**Aqua New York
Bethpage Water District
Massapequa Water District
South Farmingdale Water District**

Re: Northrop Grumman-Navy Groundwater Contamination Plume
Technical Roundtable Meeting Held on September 15, 2011

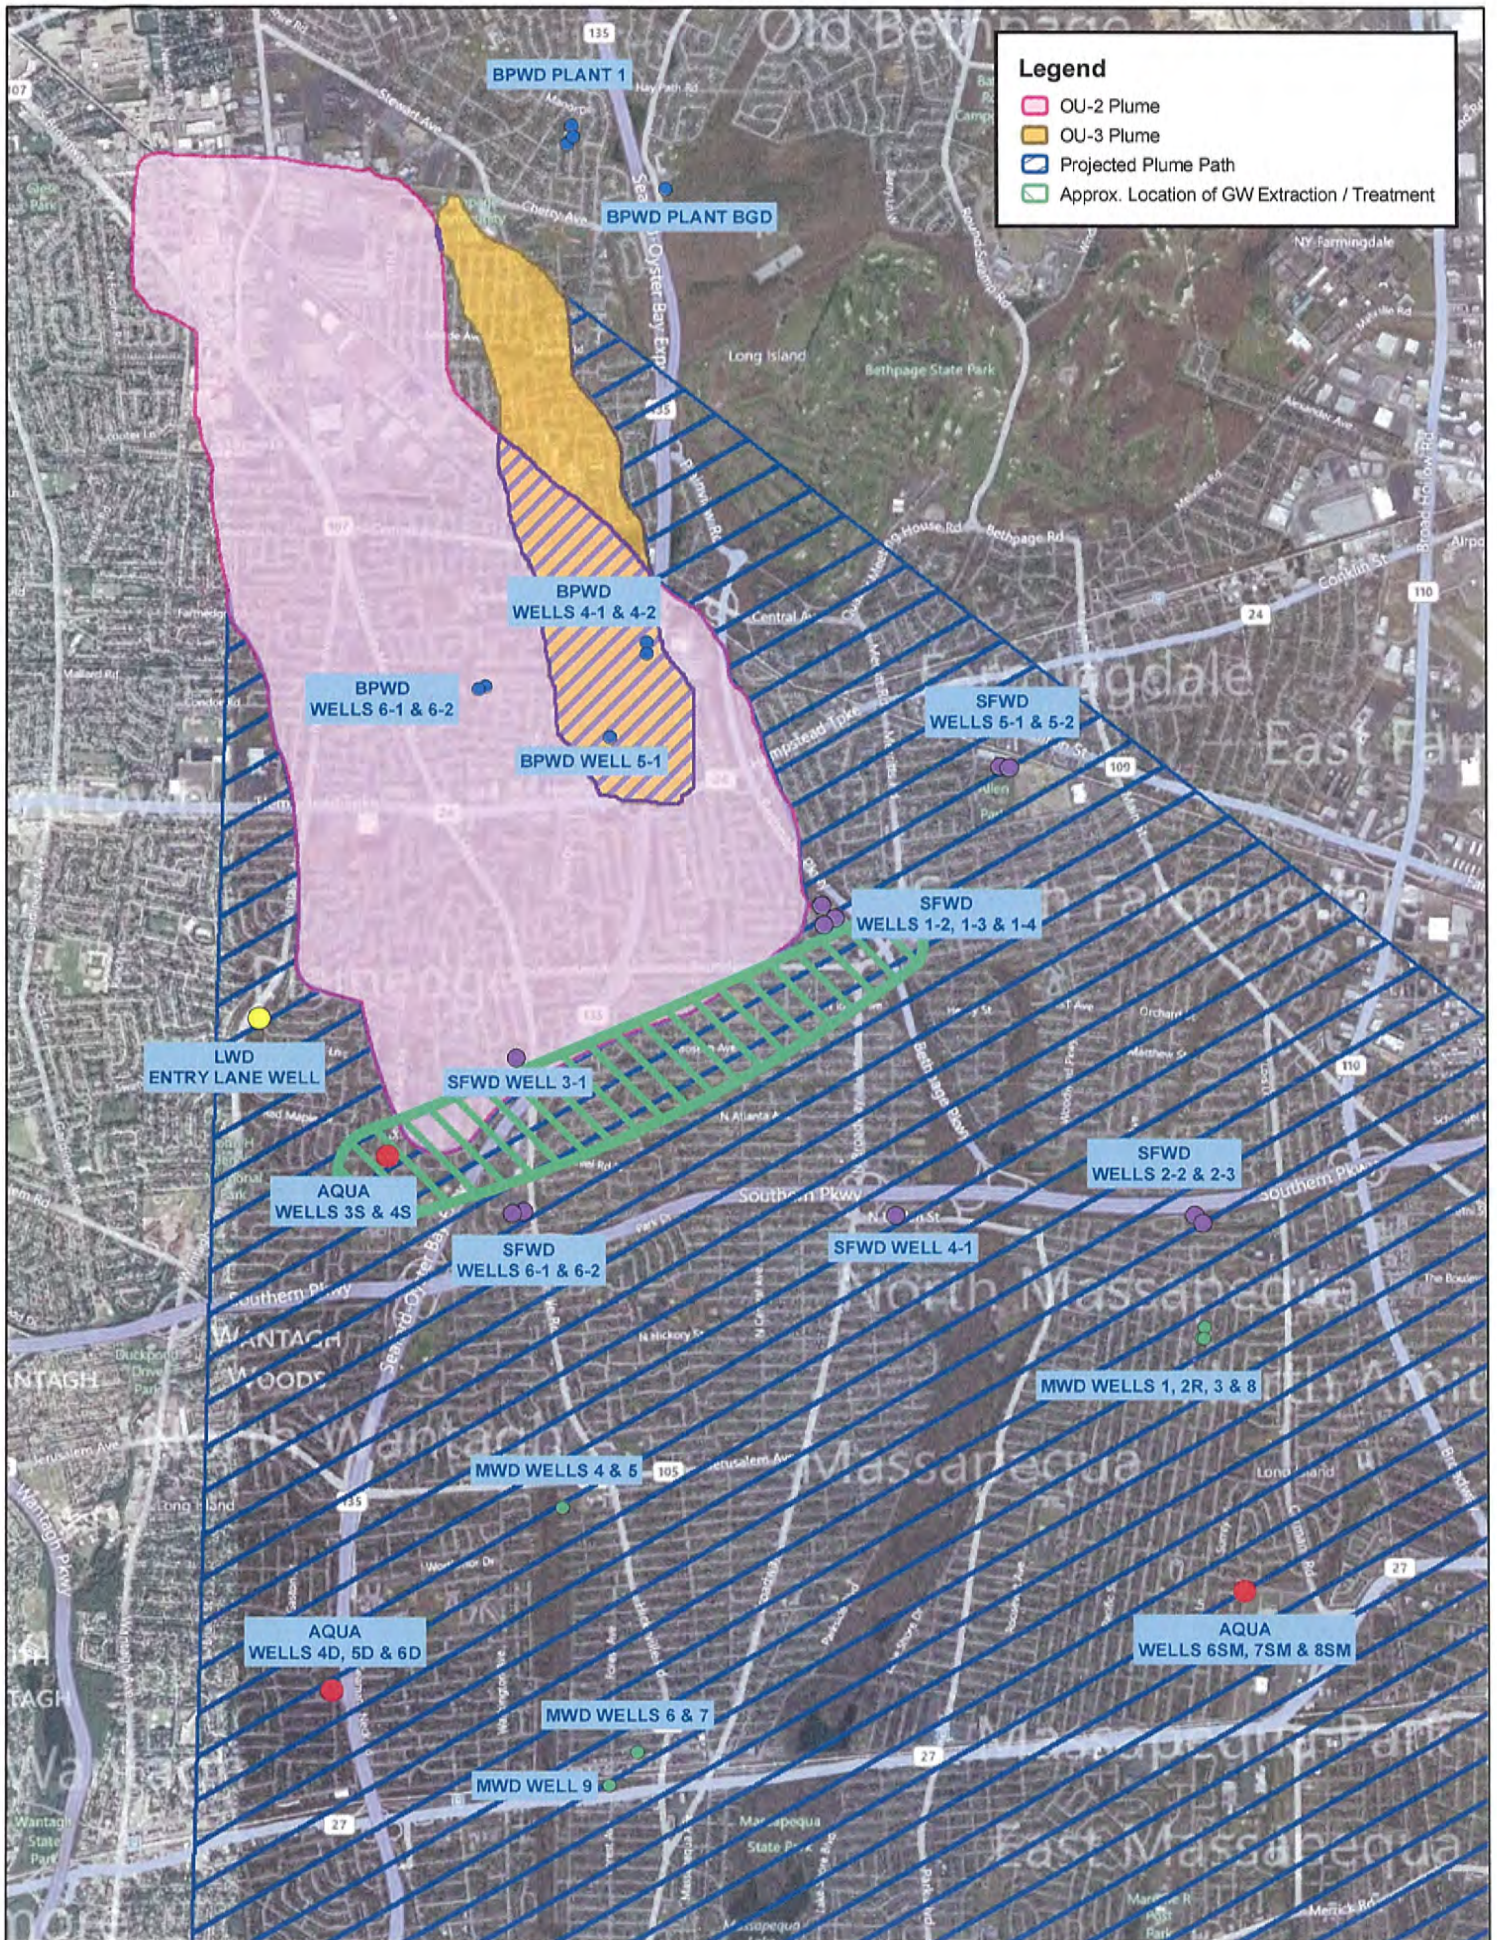
- d. The NYSDEC must consider plume containment of the entire comingled OU-2 and OU-3 plume. A preliminary concept is illustrated on the attached map. Given an average horizontal groundwater flow rate of 1 foot per day, a conceptual hydraulic barrier of 12,000 feet wide by 600 feet deep by 1 foot thick, and an average porosity of 25 to 40%, a preliminary theoretical withdrawal rate of approximately 20 MGD would be needed in the identified zone. This conceptual approach will protect the non-impacted South Farmingdale, Aqua and Massapequa supply wells. We look forward to reviewing the Navy study that is presently underway and our anticipated review of its evaluation and findings related to plume containment.
